Agenda Item # 2 SUB-003182-2024

Replat of Lot 1, Resubdivision of La Louisiana
Plantation 2 Subdivision

APPLICATION NUMBER 2 DATE January 16, 2025

DETAIL SITE PLAN

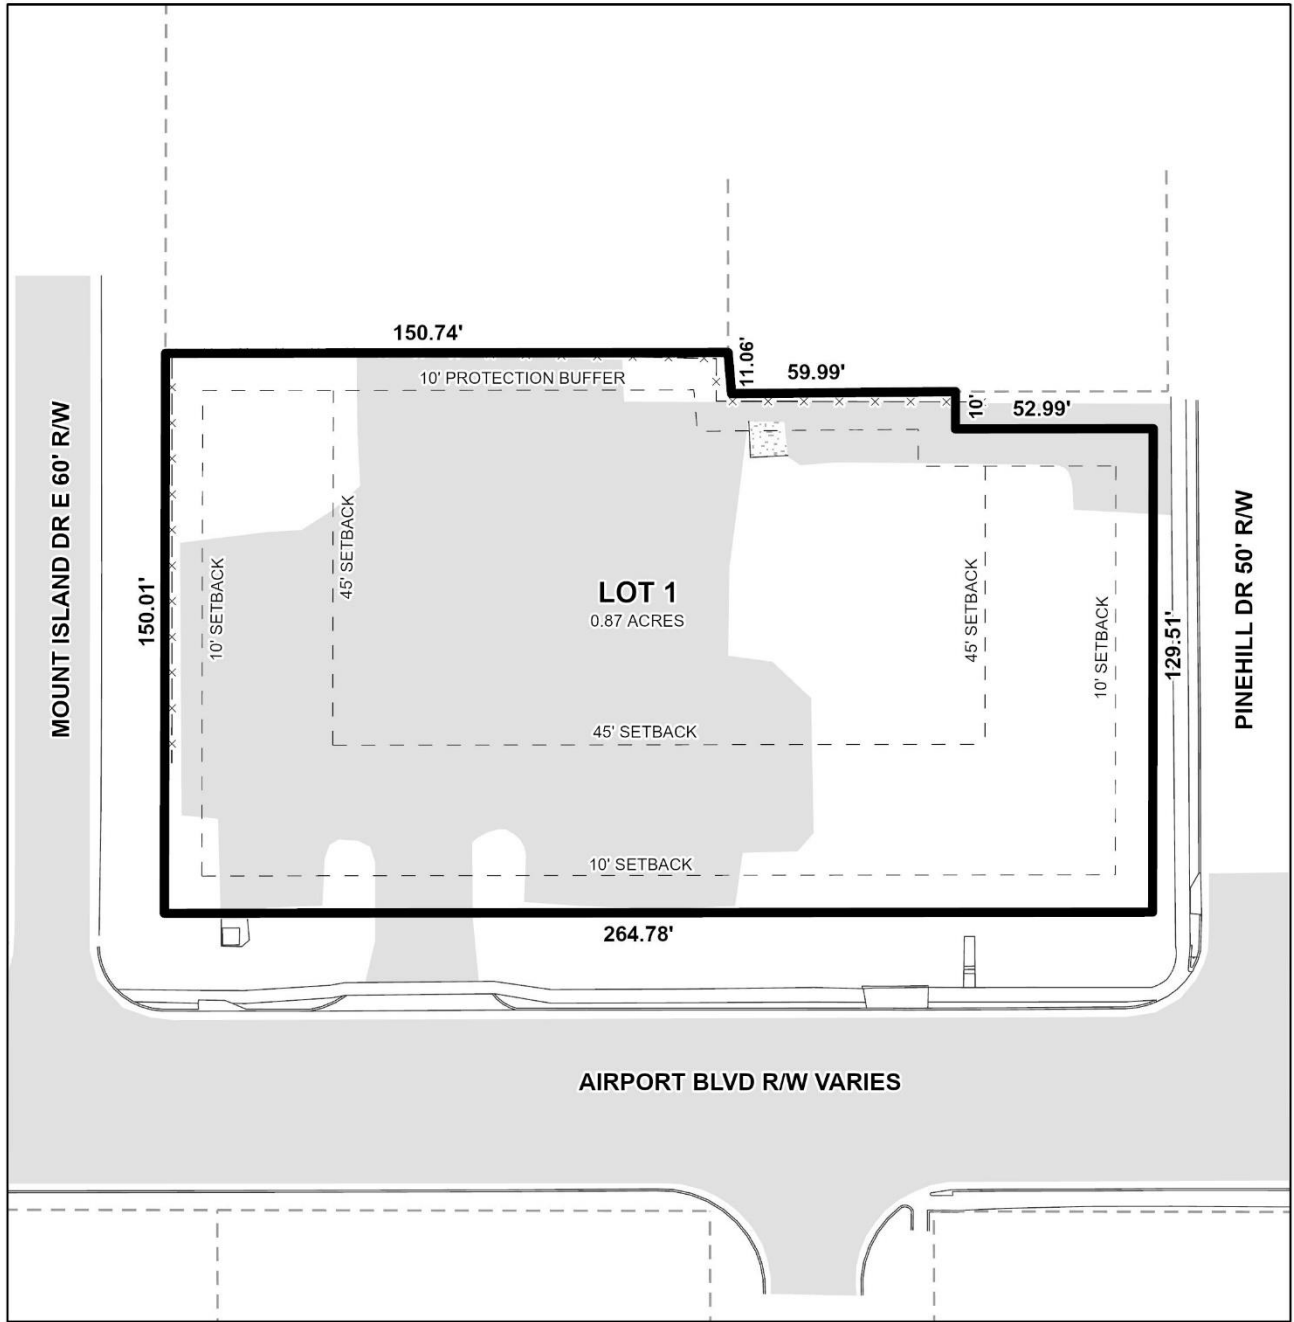
The applicant is requesting to remove the note from the most recently recorded plat limiting access to Airport Boulevard. The applicant also proposes to amend the previously recorded plat for this site to reduce the minimum building setback line from the 25 feet (25') to ten feet (10'), per the current Unified Development Code (UDC) standard for lots in a B-2 Urban District.

If approved, the plat should be revised to illustrate a 25-foot radius curve where Airport Boulevard and Pinehill Drive intersect, per Section 6.C.6. of the Subdivision Regulations.

As previously stated, one reason for this application is to amend the previously recorded 25-foot minimum building setback line to the current standard ten feet (10'). The preliminary plat illustrates a ten-foot (10') minimum building setback line along all street frontages, in compliance with Section 6.C.8. of the Subdivision Regulations, and with Article 2, Section 64-2-13.E. of the UDC for lots in a B-2 Urban District. However, the

setback line along Mount Island Drive East should be removed as the site does not actually have frontage along that street. There is a ten-foot (10') City park strip between the Mount Island Drive East right-of-way and the subject site, as recorded with Mount Island Subdivision in 1949. That strip has never been vacated and is still City property. The previously approved and recorded Resubdivision of La Louisiana Plantation 2 Subdivision of 2005 erroneously omitted the City park strip, and also erroneously indicated Mount Island Drive East with a 30-foot (30') right-of-way width from the centerline to include the area of the City park strip as right-of-way. The current right-of-way width is actually 50 feet (50'). As such, if approved, the plat should be revised to remove the minimum building setback line along the West boundary of the subject site. If approved, the plat should also be revised to indicate the ten-foot (10') City park strip adjacent to the West property line, and also revise the Mount Island Drive East right-of-way width to 50 feet (50').

The R.O.W. / PROPERTY LINE label along the West boundary should be revised to remove the R.O.W. portion. The ten-foot (10') minimum building setback line along Airport Boulevard and Pinehill Drive should be retained on the Final Plat, if approved, adjusted for any required dedication. The plat should also be revised to remove the 45-foot (45') maximum building setback lines and the ten-foot (10') protection buffer lines, if approved.

1. Retention of the right-of-way widths of Airport Boulevard and Pinehill Drive on the Final Plat;
2. Revision of the right-of-way width of Mount Island Drive East to 50 feet on the Final Plat;

3. Dedication of a 25-foot radius curve at the intersection of Airport Boulevard and Pinehill Drive;
4. Retention of the lot size label in both square feet and acres on the Final Plat, adjusted for any required dedication, or the furnishing of a table on the Final Plat providing the same information;

5. Retention of the ten-foot (10') minimum building setback line along Airport Boulevard and Pinehill Drive, adjusted for any required dedication;
6. Revision of the plat to remove the minimum building setback line along the West boundary line;

7. Revision of the plat to illustrate the ten-foot (10') City park strip adjacent to the West boundary line and East of the Mount Island Drive East right-of-way;

8. Revision of the plat to remove the R.O.W. label from the R.O.W. / PROPERTY LINE label along the West property line;
9. Revision of the plat to remove the 45-foot (45') maximum building setback lines and the ten-foot (10') protection buffer lines;
